ERRATA

Illinois Route 47 (Reed Road to U.S. Route 14) McHenry County, Illinois

Job No. P-91-101-07

August 10, 2016

McHENRY COUNTY

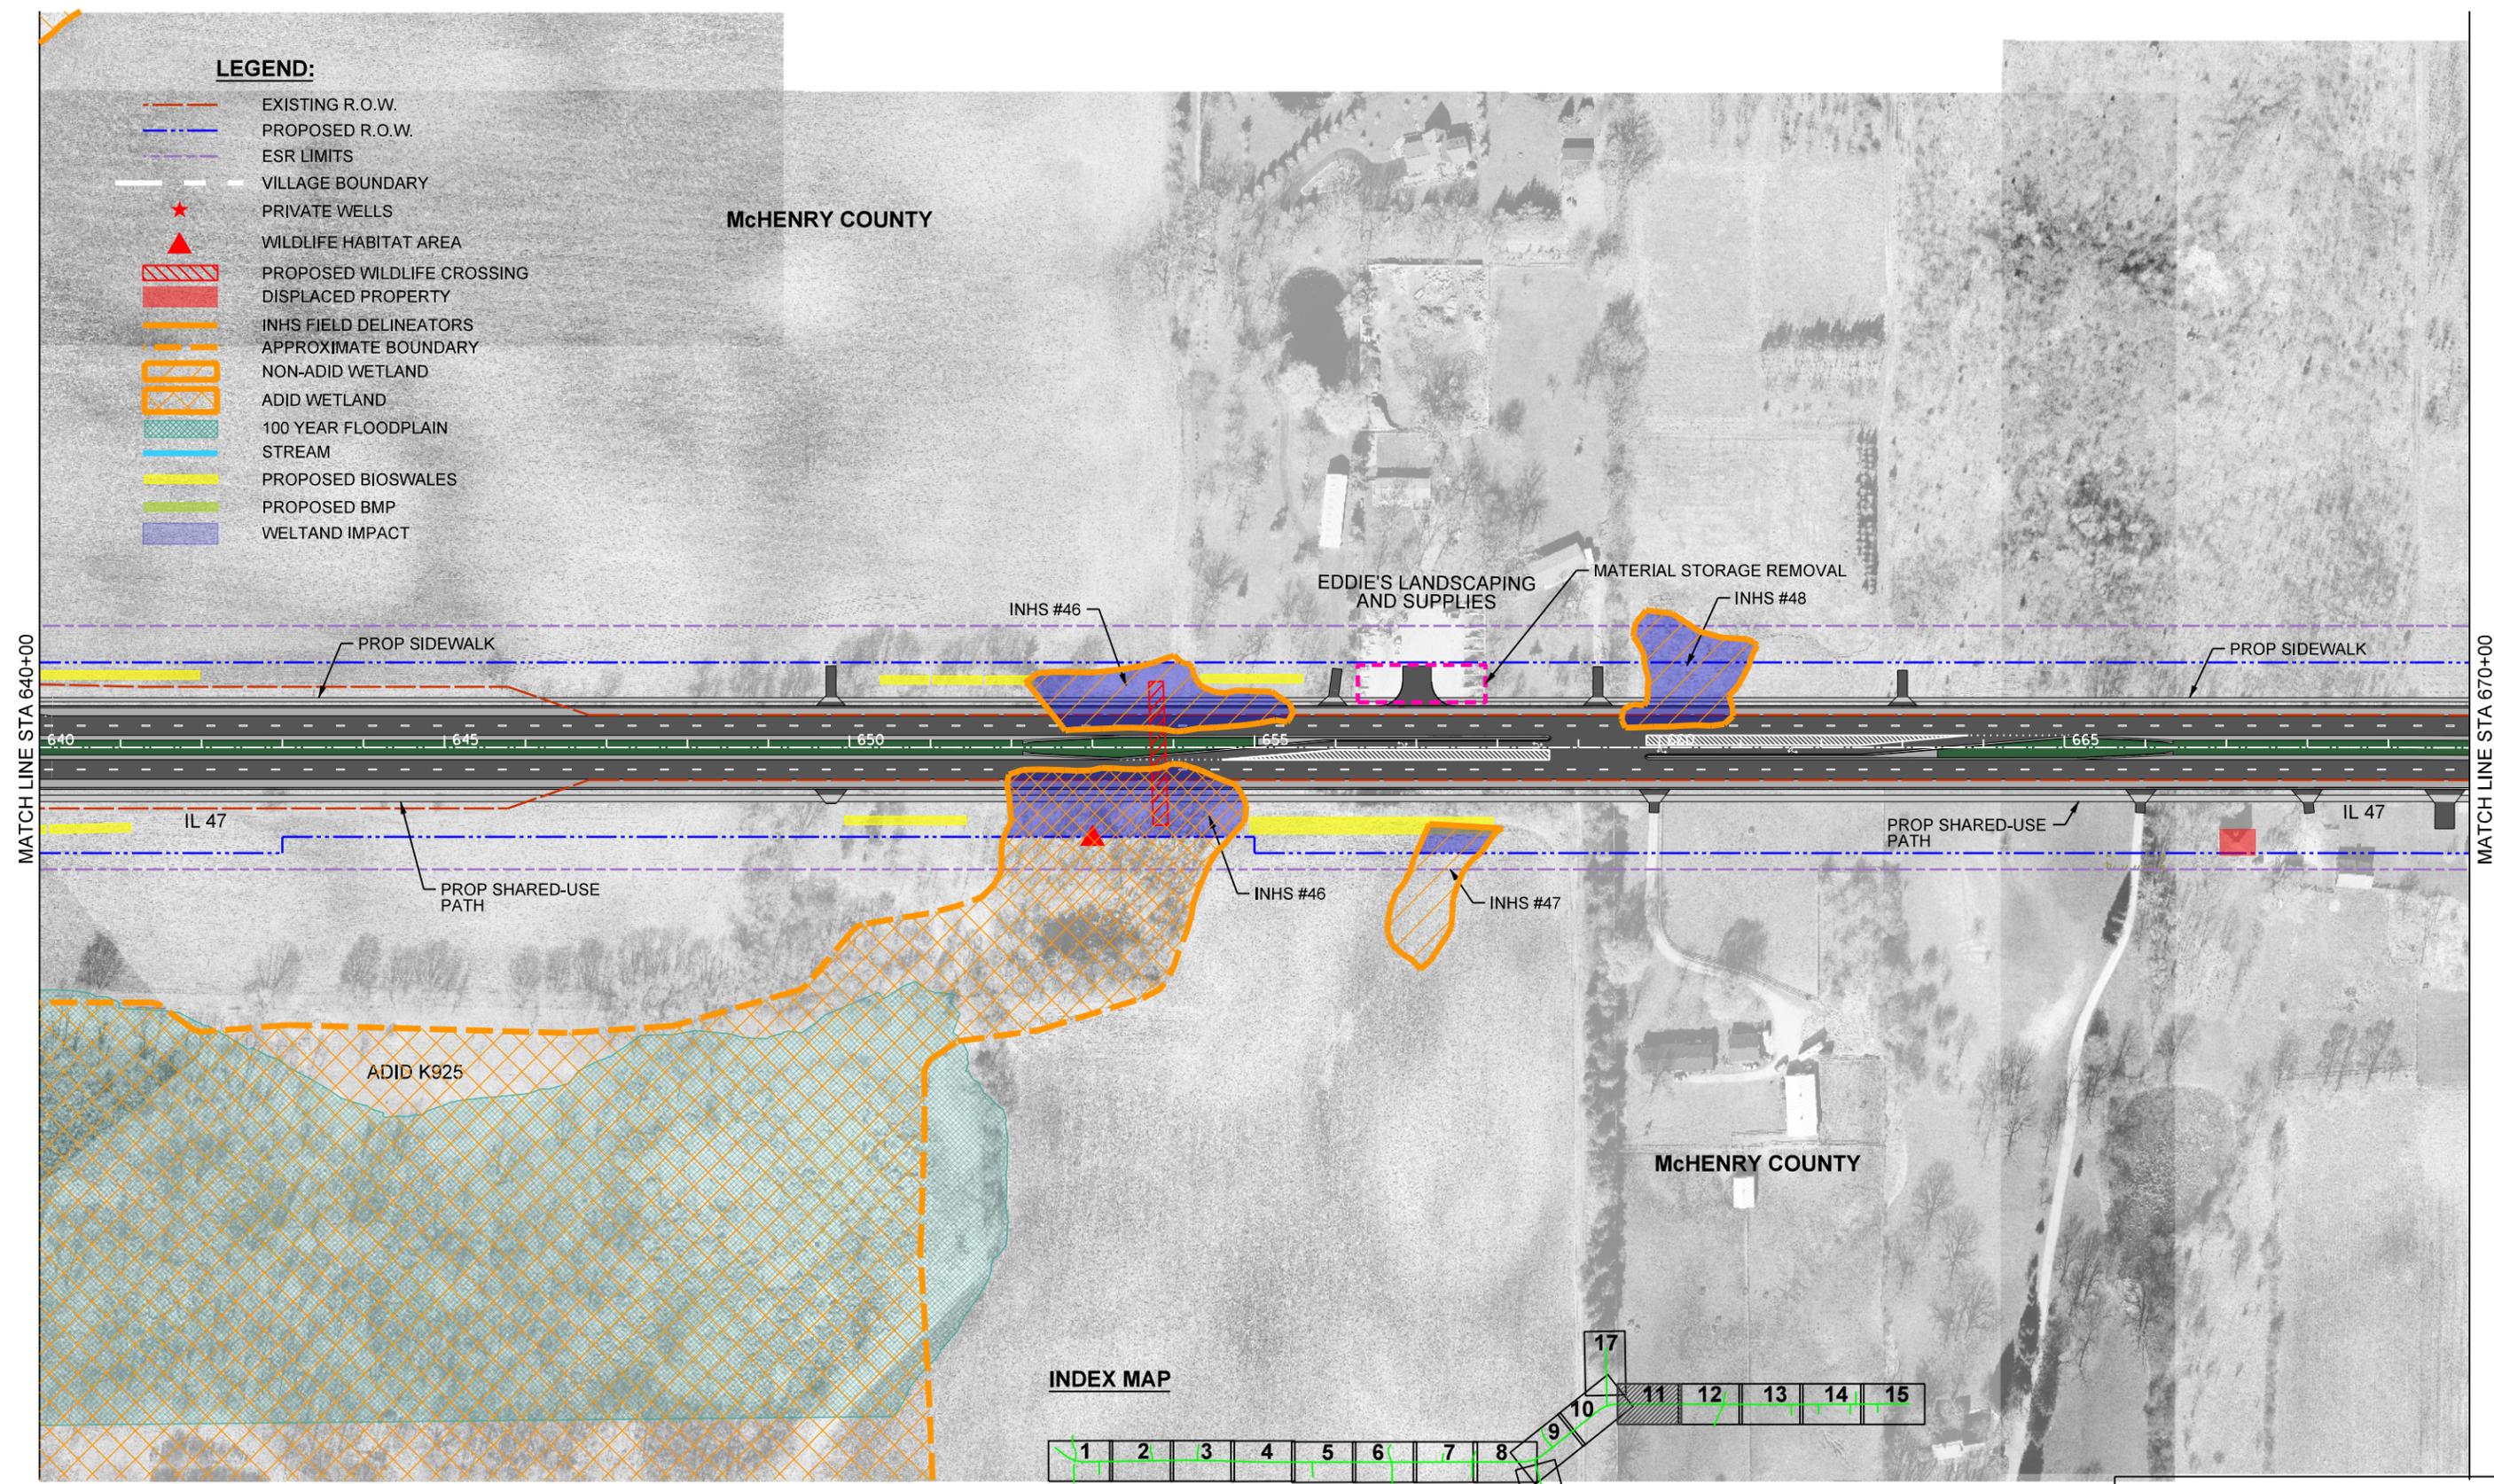
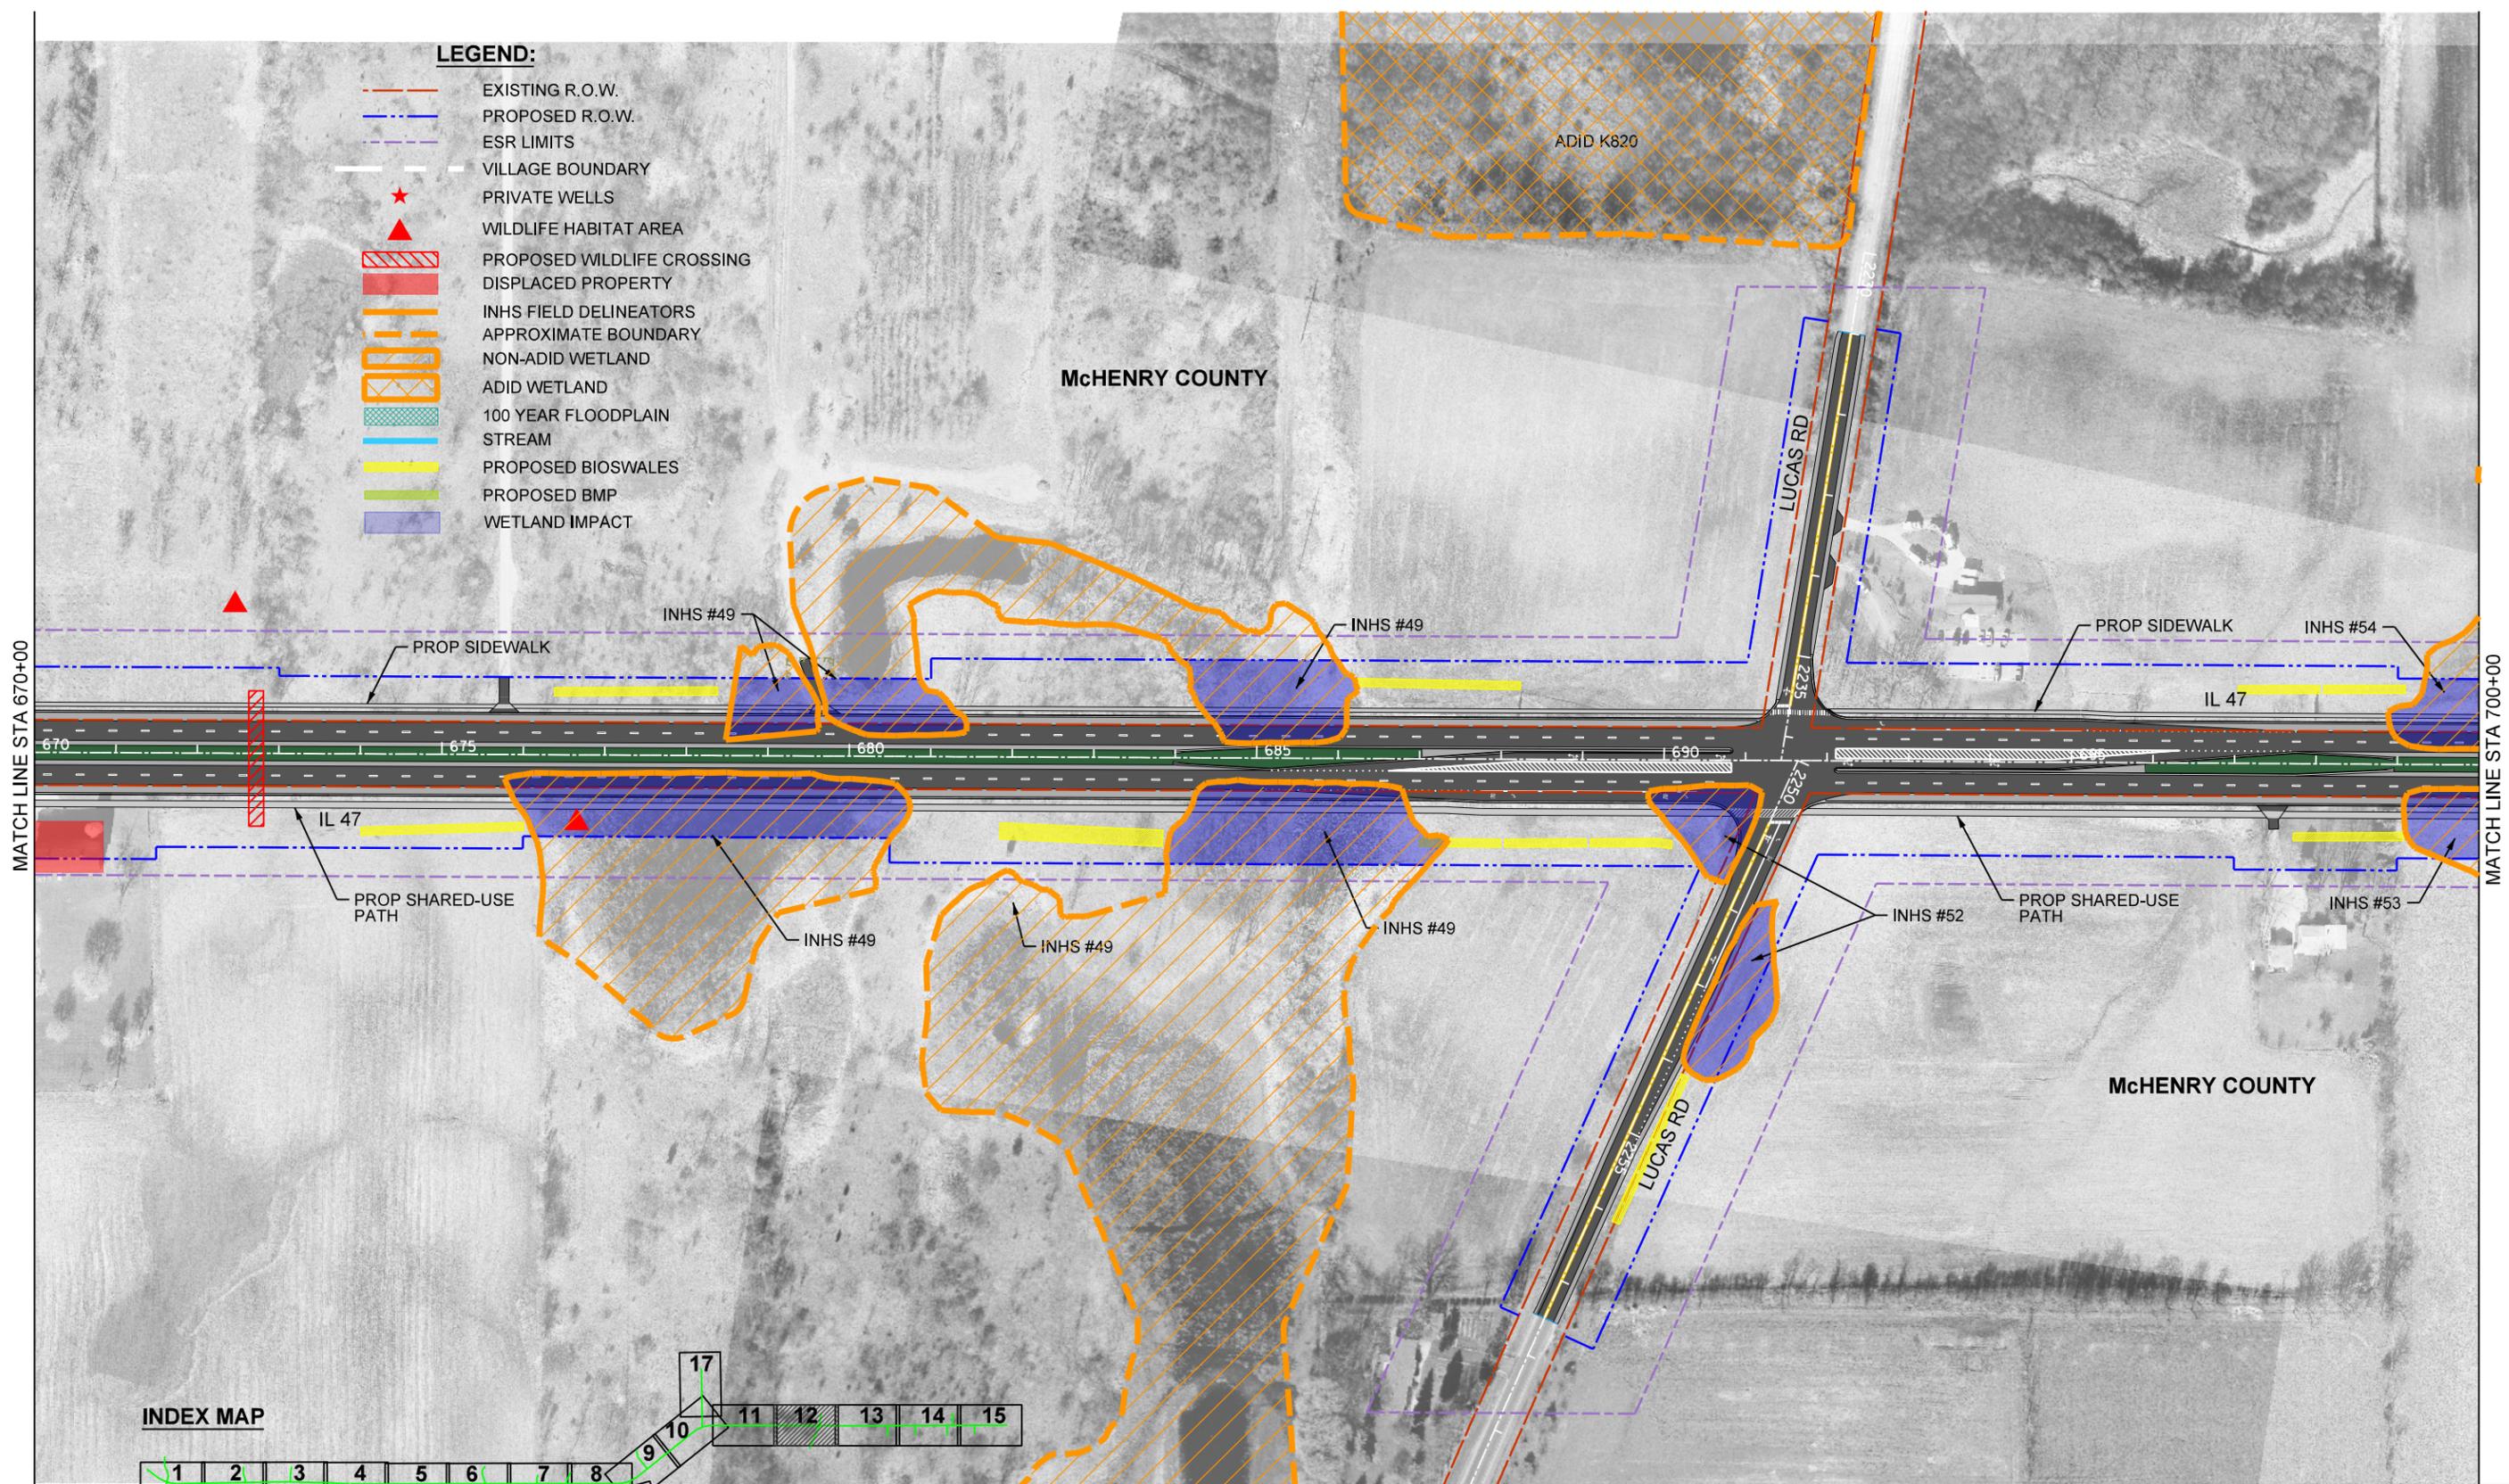
Replace Exhibit 4-1 Environmental Constraints Map to show updates to waterway names to be consistent with the Environmental Assessment, revised symbolization of the bioswales and inclusion of additional BMPs.

R	<p>A revised exhibit with a non-conflicting color scheme has been included in the Errata.</p>
87	U.S. Army Corps of Engineers	C	<p>The bioswale locations in Exhibit 4-1 should not be located within delineated wetlands or streams. Exhibit 4-1 should be revised accordingly for the final EA;</p>
		R	<p>The exhibit has been revised showing potential new locations as necessary. However, since the wetland impacts were considered to be everything within the ROW, those areas are proposed ditch locations where BMPs or bioswales are proposed; there may no longer be a functioning wetland due to construction disturbance. The design engineers will consider where regrading for the roadway and ditch work will take place while minimizing any impacts. However, there will be situations where the wetland will be graded out as part of the roadway and/or ditch construction, but these locations may be replaced with a bioswale.</p>
